COUNCIL AGENDA

PLANNING AND RELATED MATTERS

Wednesday 26 October 2022

5.1 9-13 & 15 BARROW STREET, COBURG - PLANNING PERMIT APPLICATION MPS/2021/1017

DRAWING:
NO.9-15 - GROUND FLOOR PLAN
WITHOUT PREJUDICE - FOR DISCUSSION ONLY

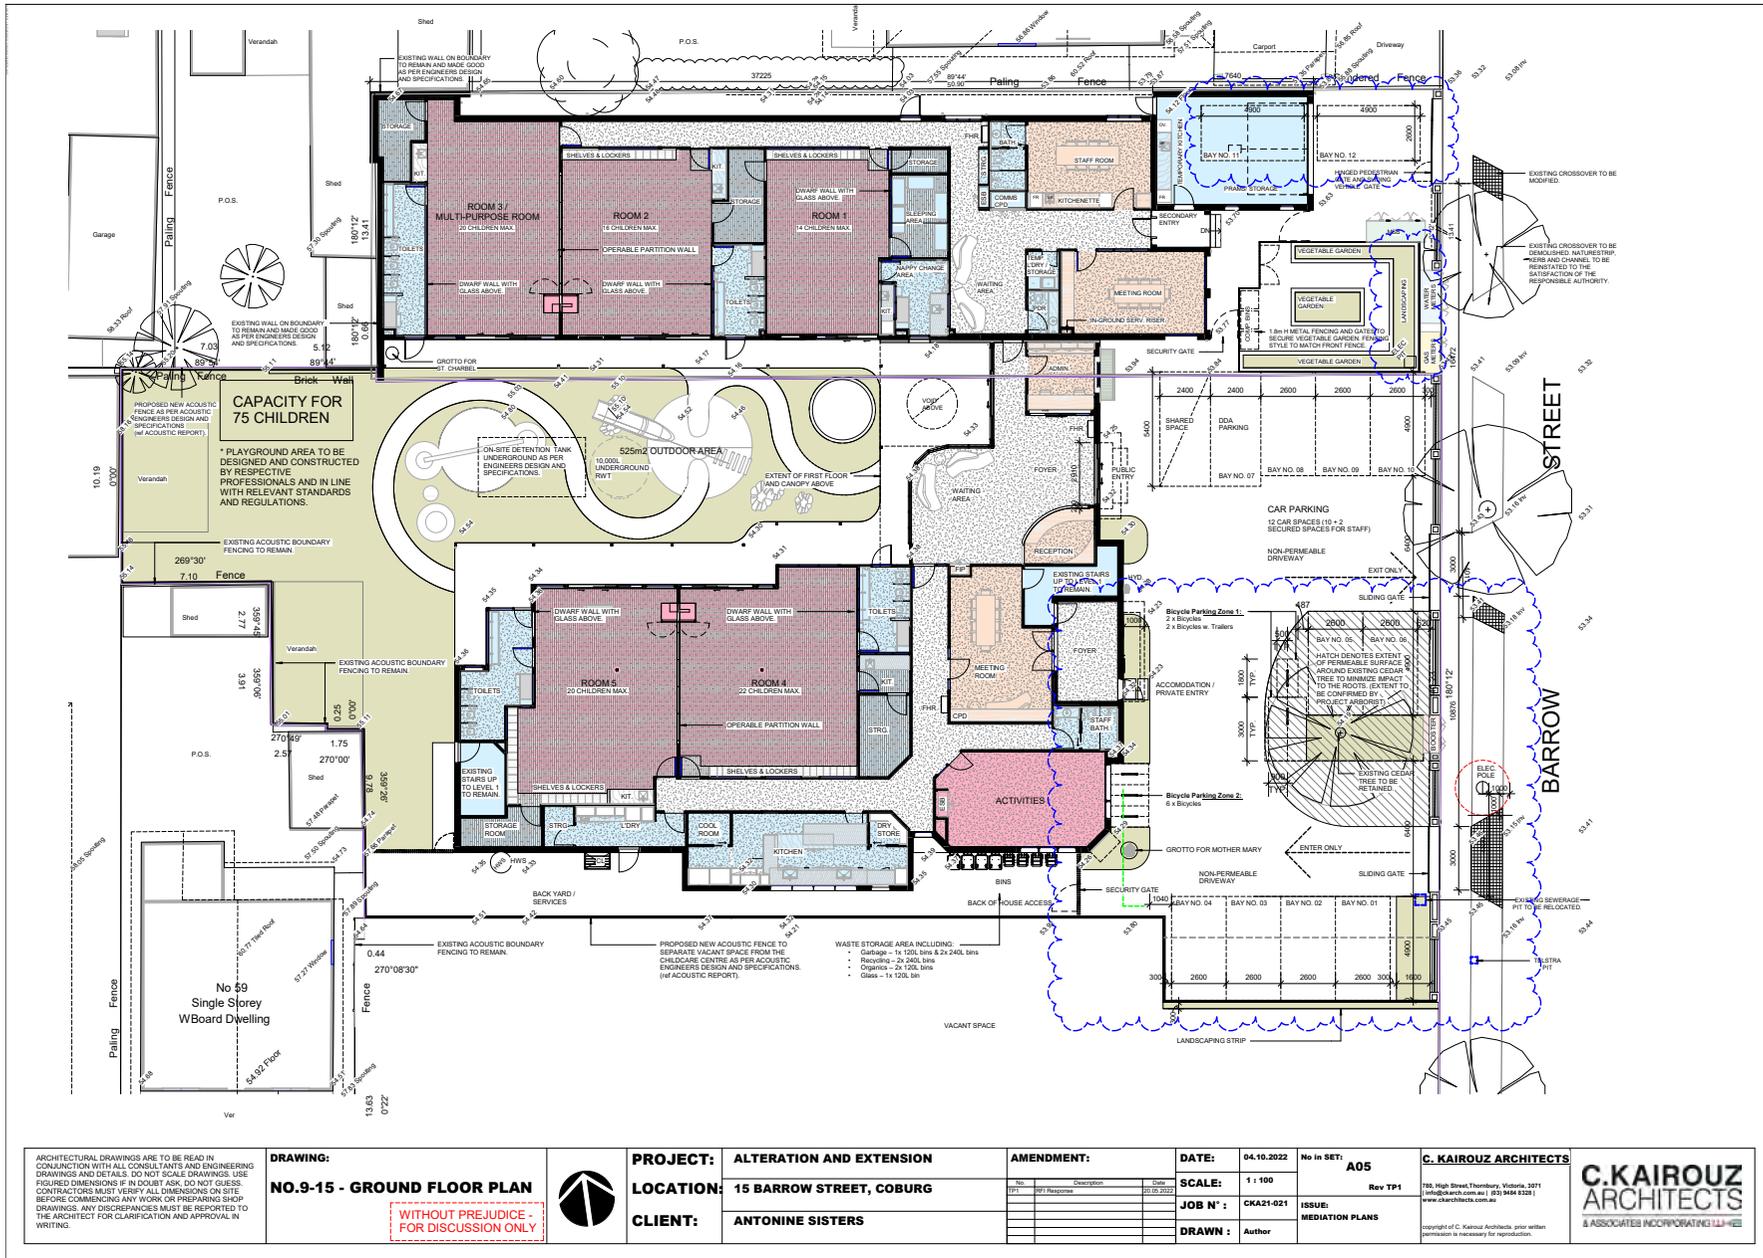
- vi. The addition of a landscape bed to the south of the southernmost car park spaces.
 - vii. An additional car space within the “pram store room/storage” and the space in front indicated on the plans. These spaces are to be marked for staff use only and must be shown to comply with the requirements of Clause 52.06-9 of the Moreland Planning Scheme.

- d) The bicycle parking spaces relocated out of the 0.3 metre wide “clearance required” area of the adjacent car spaces.
 - e) Any changes in accordance with the Tree Management Plan (TMP) required under condition 6 to ensure the retention of the cedar tree.

DRAWING:
PROPOSED ELEVATIONS
WITHOUT PREJUDICE - FOR DISCUSSION ONLY

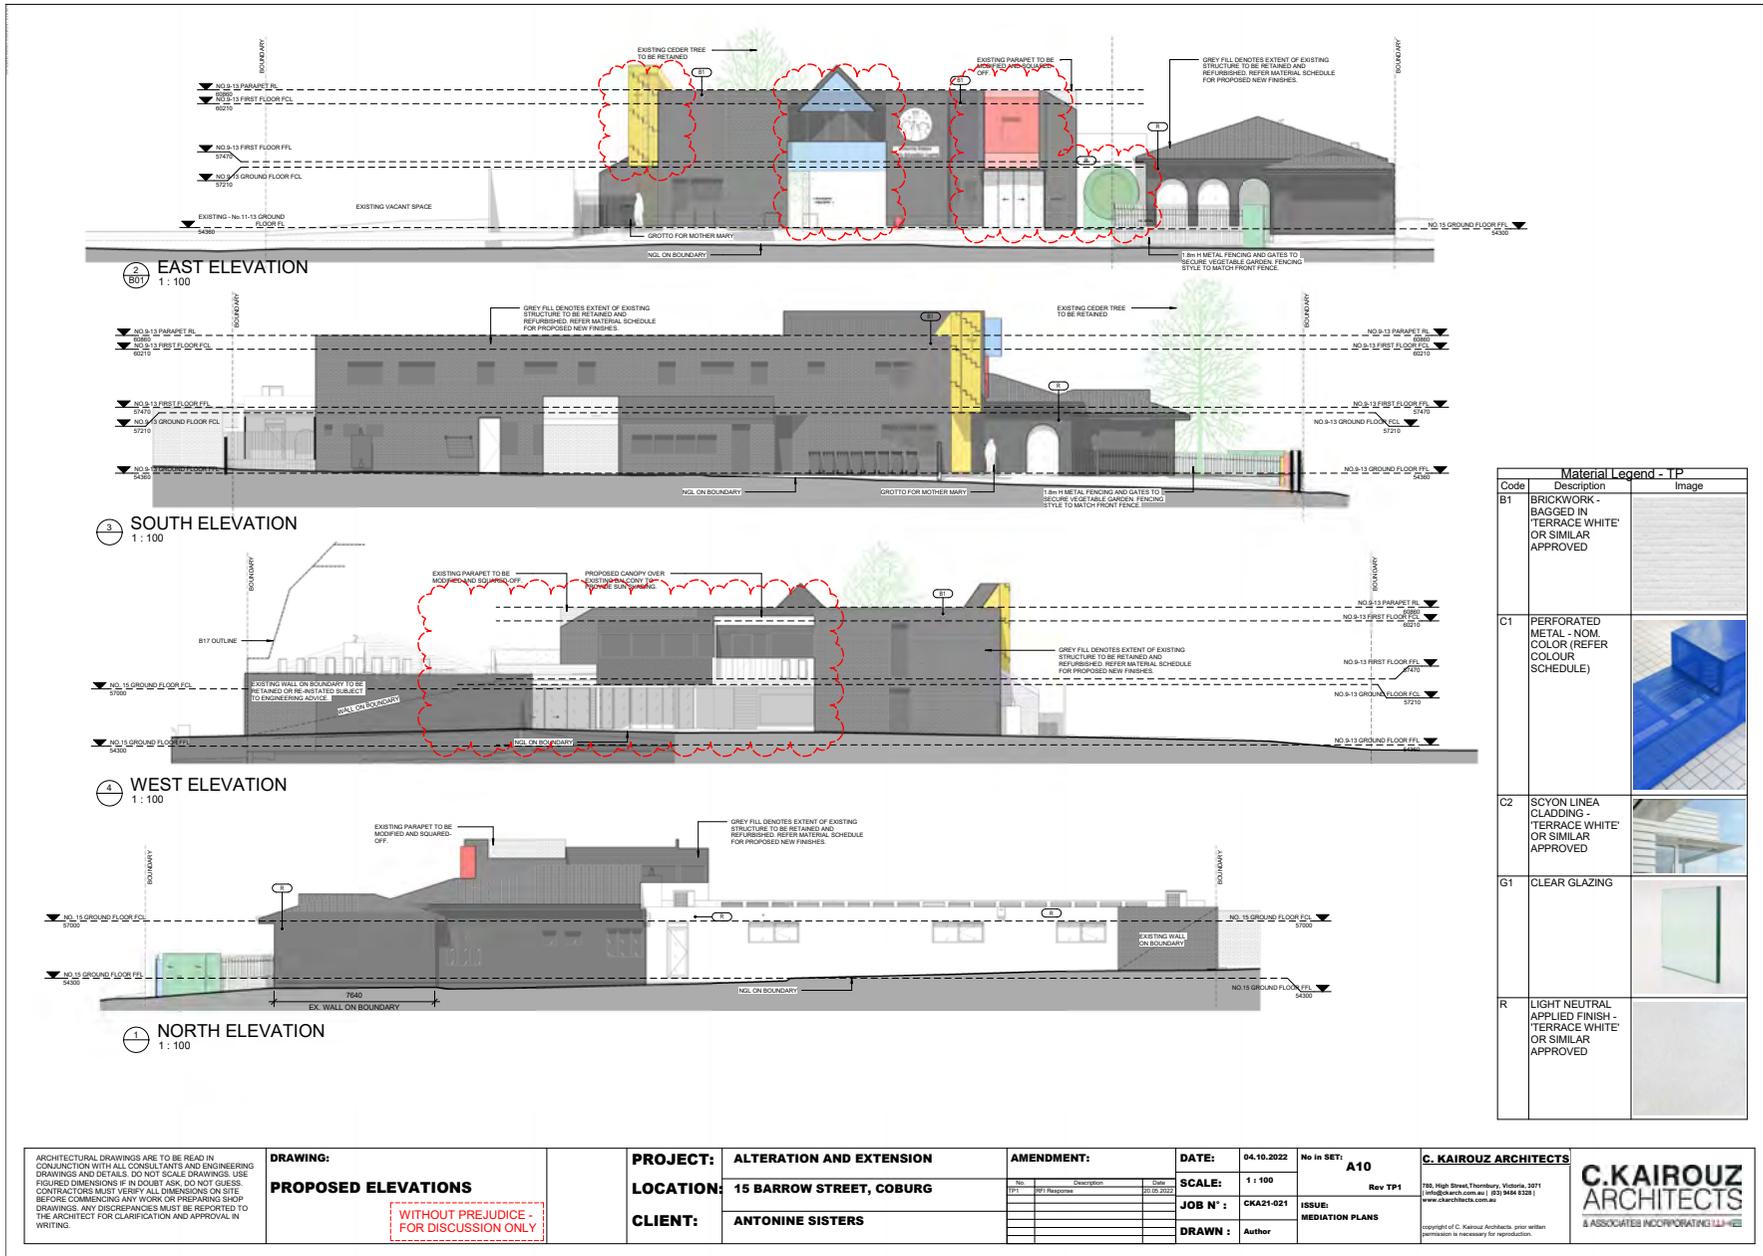
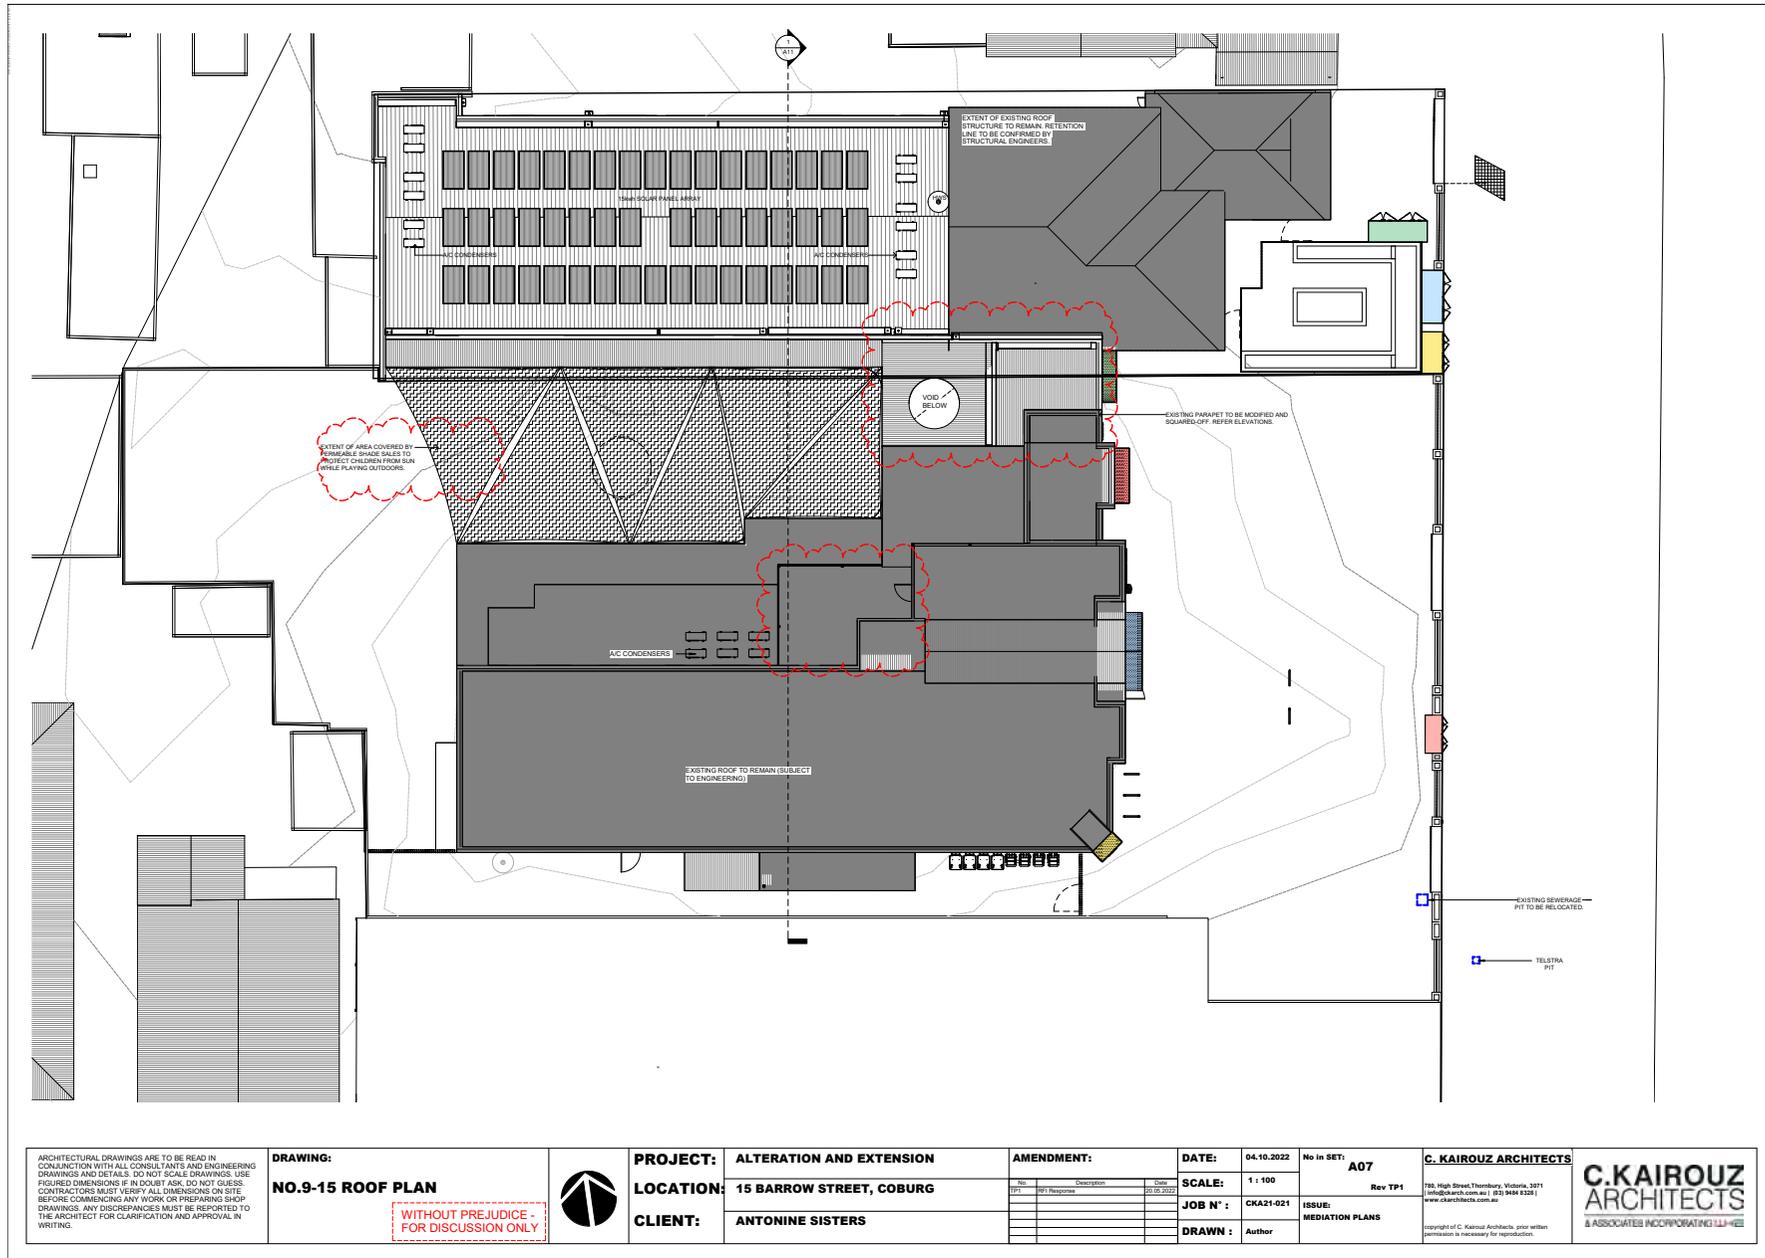
- a) Changes generally in accordance with the discussion plans dated and received on 4 October 2022, including:
 - i. Alterations to façade colours, materials and glazing, and the design of the feature shapes with all materials on the material schedule and clearly linked to the elevation plans.

The discussion plans show these windows as removed to accommodate increased solar panels. This change will be required via a condition of the permit. This will negate the concern about noise from the windows.
